REVISED RESPONSE TO REQUEST FOR ADDITIONAL INFORMATION**APR1400 Design Certification****Korea Electric Power Corporation / Korea Hydro & Nuclear Power Co., LTD****Docket No. 52-046**

RAI No.: 131-8087

SRP Section: 11.05 - Process and Effluent Radiological Monitoring Instrumentation and Sampling System

Question No. 11.05-1

Figure 11.5-2Z Location of Radiation Monitors at Plant (Turbine Generator Building El. 170'-0")

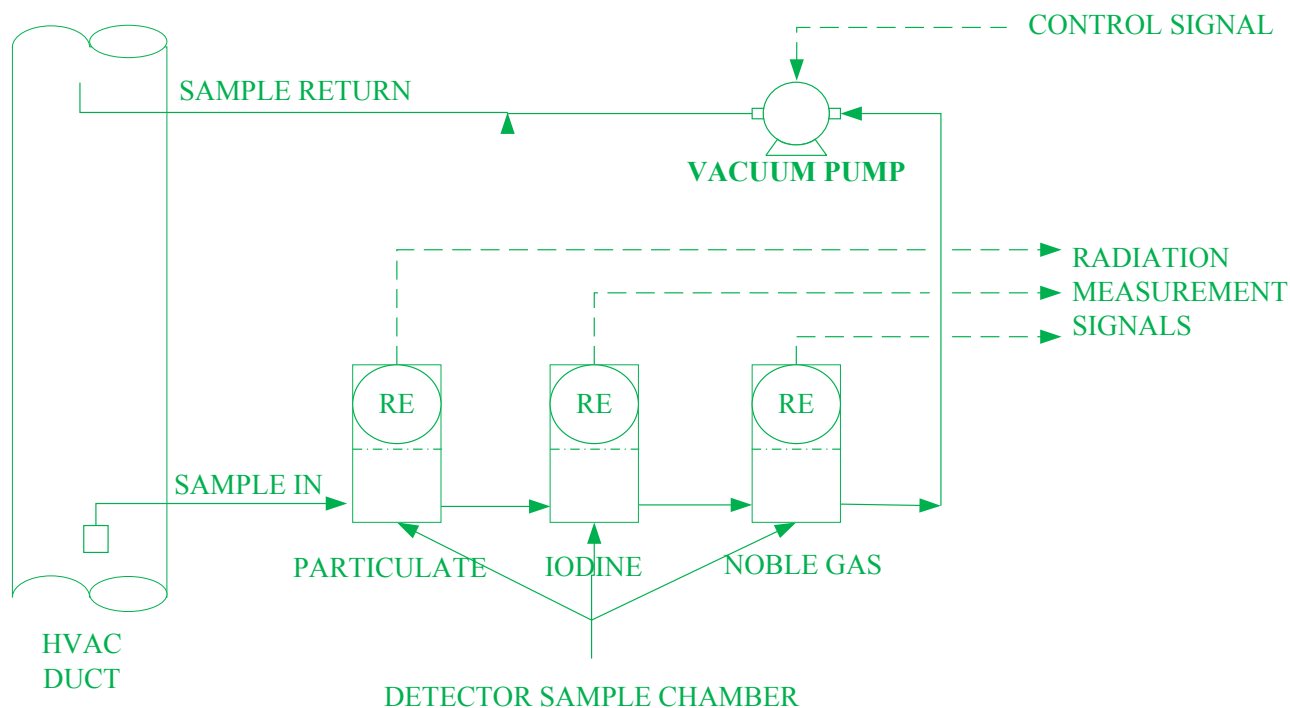
Information contained in DCD section 11.5.2.2 does not include the level of detail SRP section 11.5 describes for the description for the PERMSS. The description of monitors in DCD section 11.5.2.2 for the Gaseous PERMSS, and the detectors functions are not completely described in Table 11.5-1. There are several instances where a detector will have the function and remark of "Alarm (MCR)" but have no clarifying detail to describe these functions in DCD section 11.5.2.2. Upon inspection of Tier 1 Section 2.7.6.4 NRC staff observes that there are indications not described in Section 11.5 that are seen in Tier 1 Table 2.7.6.4-1. Tier 1 Table 2.7.6.4-1 has a column to describe any Display/Alarm at MCR/ or RSR indication. Each detector in this TIER 1 table has a "Yes" marked for all three indications, however DCD Section 11.5 does not include a full description of all indications in either the text or DCD Tables 11.5-1.

Figures 11.5-2 will be revised to show the correct location of the radiation detectors (RE) and the monitor electronics/displays (RT). In the figures, RE/RT means that the detector and electronic/display are installed together adjacent to each other. The location of some RE and RT have been changed to the correct location. Subsection 11.5.2.2.5 will be added to describe that the location of each monitor is shown in Figures 11.5-2.

The monitor is located in Turbine Generator Building as shown in Figure 11.5-2Z.
